70 North Road, TW9 4HQ

Roof extension and single storey side and rear extension

Design and Access Statement

1067 AL(00)1011 Rev 3 December 2024

70 North Road roof viewed from Atwood Avenue

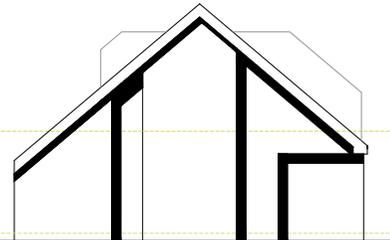
The larger window to the upper floor is not considered acceptable and a more traditional design should be adopted given the visibility of the rear upper floor from Atwood Avenue.

With the removal of the gable end, the revised design now incorporates a more traditional dormer window.
